From: Jessica.Ho@ccsrf.com on behalf of application.2010@ccsrf.com
Sent: Wednesday, June 29, 2011 9:55 PM
To: charvey-tcb@ccsemc.com
Cc: application@ccsrf.com; charvey@ieee.org; claire.hoque@ccsemc.com; lucy.tsai@ccsemc.com
Subject: 回信: SerComm Corporation, //P27NA900A //AN11T0440 Notice #1
Attachments: NA900 Operation Description Revised 0629.pdf; NA900 Block Diagram For System Revised 0629.pdf; NA900 User manual Revised 0629.pdf; NA900 Block Diagram For Z-Wave Revised 0629.pdf

寄件人: <charvey-tcb@ccsemc.com>
收件人: <application@ccsrf.com>
副本抄送: <charvey@ieee.org>, <claire.hoque@ccsemc.com>, <lucy.tsai@ccsemc.com>
日期: 2011/06/25 上午 04:58
主旨: SerComm Corporation, //P27NA900A //AN11T0440 Notice #1

Z-wave daughter board ←

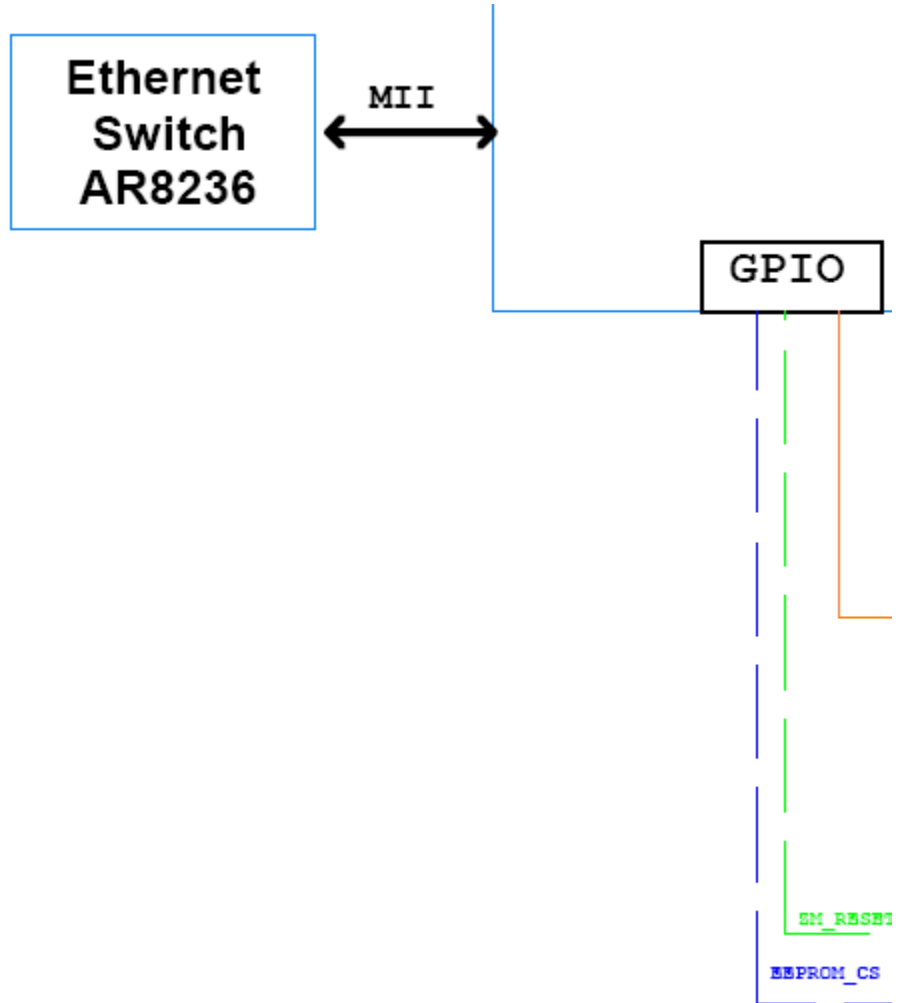
3. The Block Diagram for the Sercomm NA401 ZWave Daughter Board shows a very basic block for the ZWave Radio Module with EEPROM, but also shows a 4 Port USB hub and a Broadcom5354 which does not show up in the Schematics for either the ZWave Module or the system. Please update the Block Diagram for the 908MHz ZWave to show more detail and not include circuits that are not part of this device. It seems that the NA401 is an earlier product and not this device.

Ans: Please see the revised Block Diagram as the attachment.

Z-wave daughter board can support NA401 and NA900.

Attached is the schematic of Z-wave daughter board for NA900.

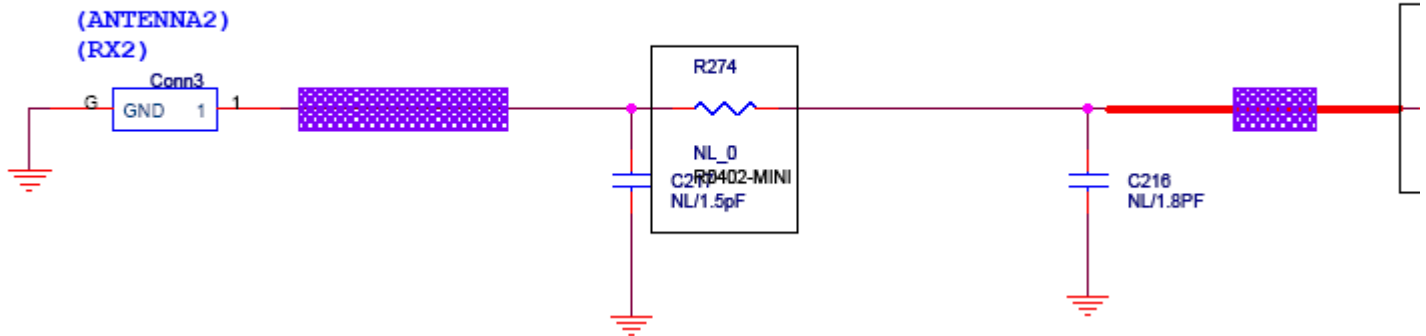
4. The User's Manual has a photograph of a PC Board that is similar to, but not identical to the PC Board shown in the Internal Photograph exhibit. Please explain this and update/replace the User's Manual as needed.

Ans: Please see the revised User's Manual page 10 as the attachment.
